MEMORANDUM

From:	Built Heritage Officer		
Service	Green Infrastructure	App No:	260594
Address:	The Rose, 30 Market Place, Wokingham, RG40 1AP		
Proposal:	Application for Listed Building consent for proposed repairs to single storey rear roof, installation of new ceiling lining to the ground floor commercial kitchen and minor alterations to the rear first floor section to facilitate use as a two bedroom staff flat.		
Heritage Asset:	Ye Olde Rose Inne – Grade II listed since 1951 Wokingham Town Conservation Area <i>Setting of:</i> The Town Hall – Grade II* 3-4 Market Place – Grade II 5 Market Place – Grade II 6 Market Place – Grade II* Roebuck Public House, Market Place – Grade II Fosters, Market Place – Grade II K6 Telephone Kiosk , Market Place – Grade II Drinking Fountain, Market Place – Grade II Red Lion Public House – Grade II* 22 Market Place – Grade II 23 and 34 Market Place – Grade II <i>Listed buildings and conservation areas are classed as designated heritage assets under the NPPF (2024) and in the Council's Local Plan policies</i>

TRADITIONAL CASEMENT WINDOWS

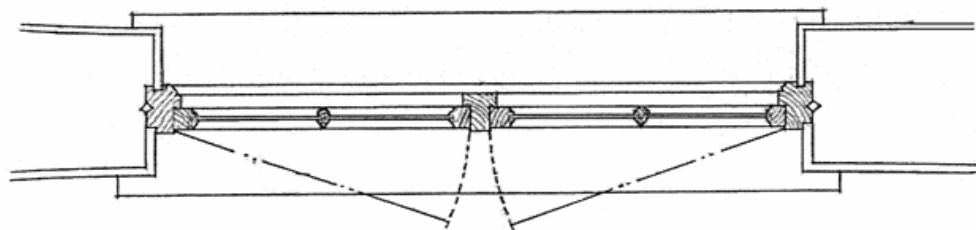
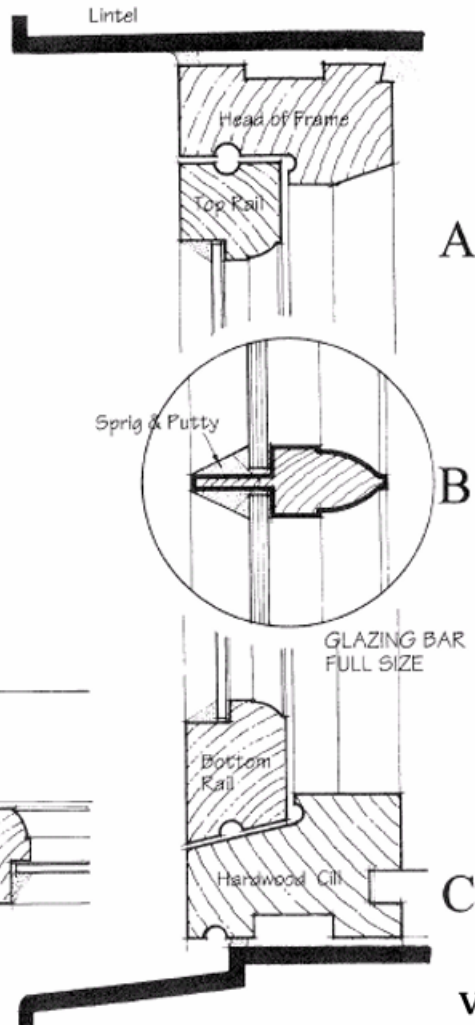
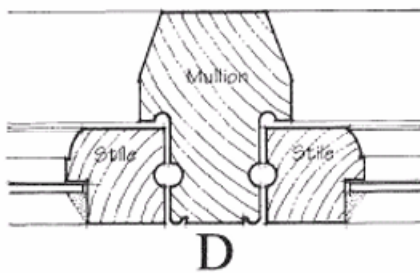
Further to this detailing, the submitted drawings are slightly remiss in that they don't include the crucial sectional and detailed elements expected for this type of window in a historic building – it would be expected to have a section showing the glazing type, dimensions, relationship with glazing bars, their dimensions, type of hinges (to be butt hinges) etc. The general proposed design, being a two-casement, side hung window is acceptable, however further details are required. It would be expected for the new window to be an exact replica of the historic ones adjacent – having Ovolo moulded glazing bars affixed with putty etc. The details are important here, as it was noticed that a poorly detailed double glazed window has been installed at first floor level in the main part of the building (at the top of the stairs, overlooking the courtyard) – no planning history can be found for this modern alteration (it appears to be 5-10 years in date) – irrespective, the detailing is inappropriate and thus it is important the new window, as proposed in this application, is appropriately detailed.

An example of the type of details required:

The only outstanding information would be the further details of the windows – as noted above the submitted drawings just need a few extra details – they also appear to show the glazing fixed with timber beading as opposed to putty – confirmation is needed on the glazing bar design, dimensions etc. And related to this, if the applicant wishes to, the replacement of the single glass pane with hit-and-miss extract – just the same level of details required for this. As the applicant has submitted all the drawings at application stage it would be assumed they do not wish this to be conditioned? That is perfectly acceptable, but this level of detail would need to be submitted prior to the grant of consent, or it can be conditioned – either or.
